Fingerboards Mineral Sands Project

Inquiry and Advisory Committee

Traffic Engineering Evidence
Stephen Hunt – Ratio Consultants

Revised Road Diversion Plan

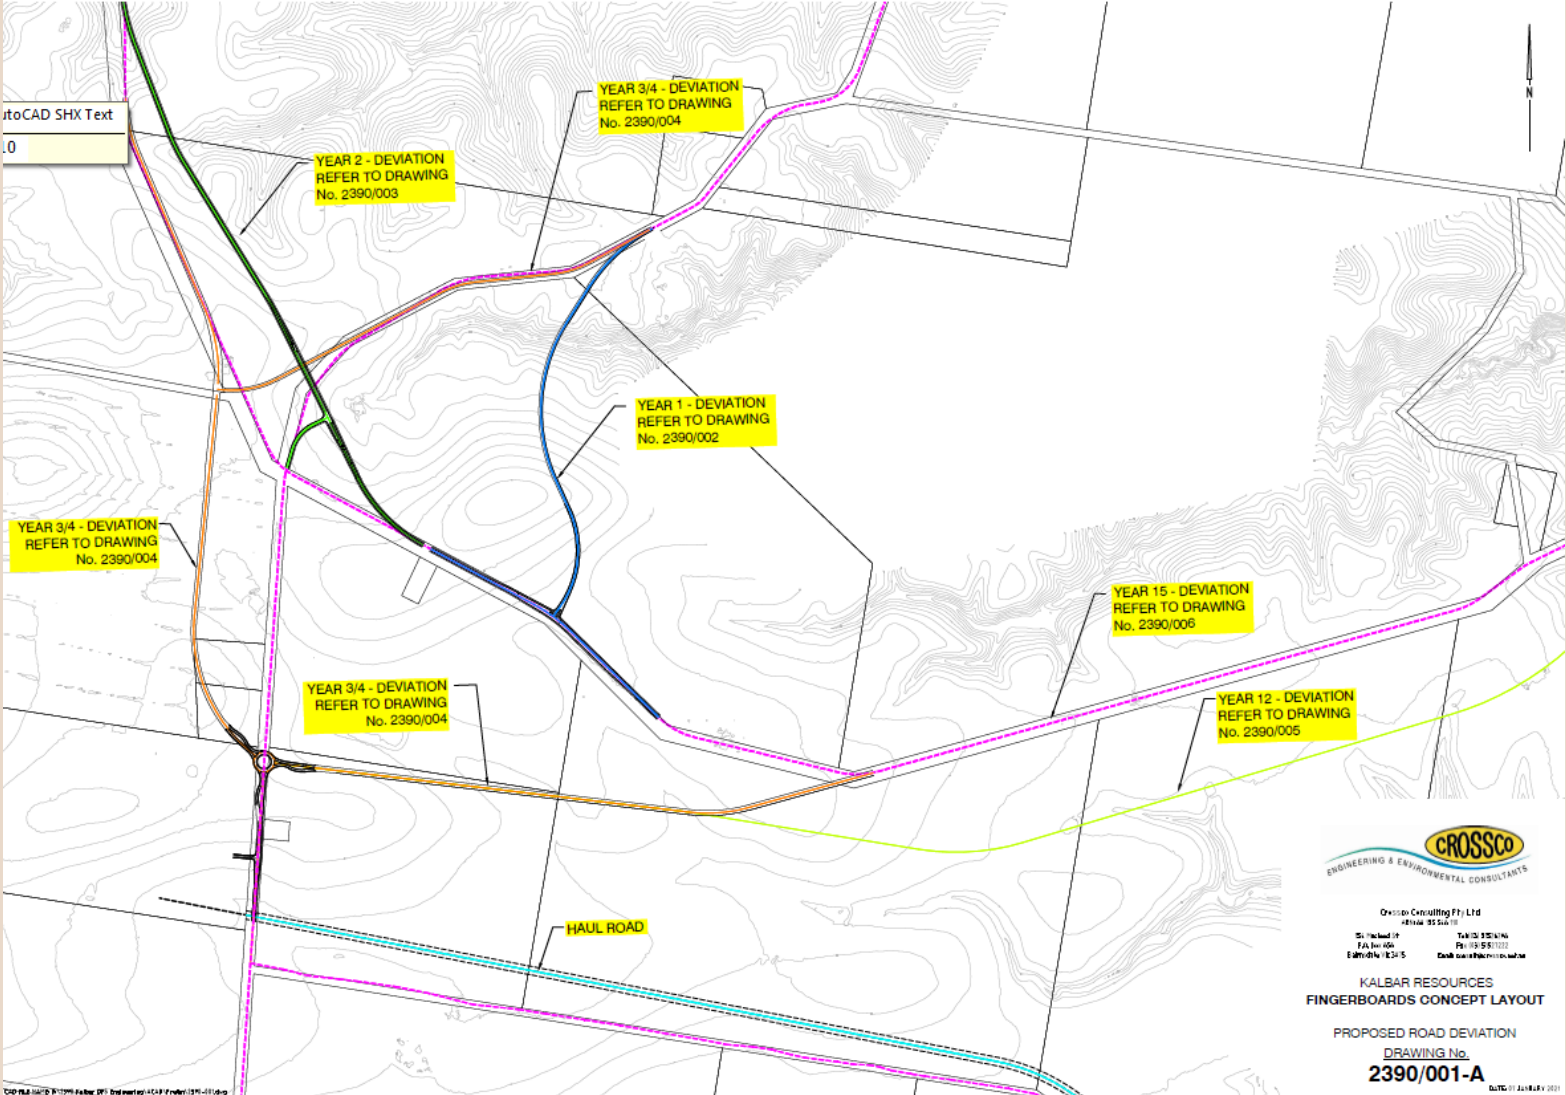
- The amended plans also relocate the Fingerboards intersection to the south, with the intersection forming a 3 leg (rather than 4leg) roundabout.
- Site access is proposed from Fernbank-Glenaladale Road 220m to the south of the roundabout and 130m north of the haulage road crossing point.

- Mr Carter in his evidence presentation, having conducted a review of the vertical geometry of Fernbank – Glenaladale Road, assess that the site access intersection and haul road intersection will have to be move further north or the vertical alignment of the Fernbank-Glenaladale Road modified.

- The likely reduction in spacing between intersections exacerbates potential issues of intersection spacing and impact on traffic using Fernbank-Glenaladale Road identified in my evidence statement.

- In my opinion, in association with the review of modified road deviations and access to the site, grade separation of the haulage road and Fernbank – Glenaladale Road should be considered.

- I consider that, given the proposed spacing of intersections along Ferndale – Glenaladale Road south of the relocated Fingerboards junction and vertical alignment issues, consideration should be given to grade separating the Private Haulage Road crossing.

Post Avon Bridge Option 1
Operational Traffic
Glenaladale Road, Intersection Spaces

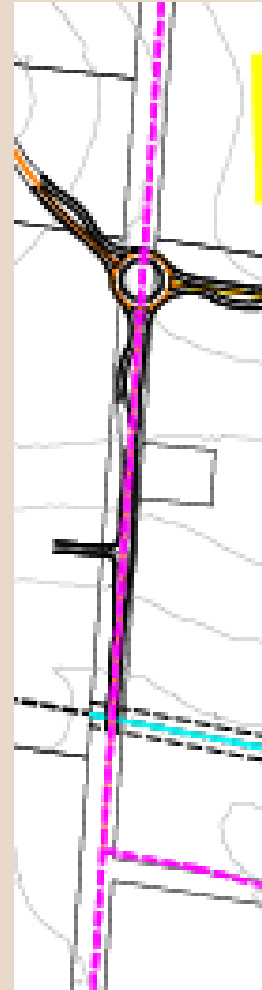
- The spacing of proposed intersections along Fernbank – Glenaladale Road is as follows:
 - Fingerboards roundabout / site access point (210m)
 - Site access point / private haulage road crossing point (150m)
 - Haulage road crossing point / Chettles Road (130m)
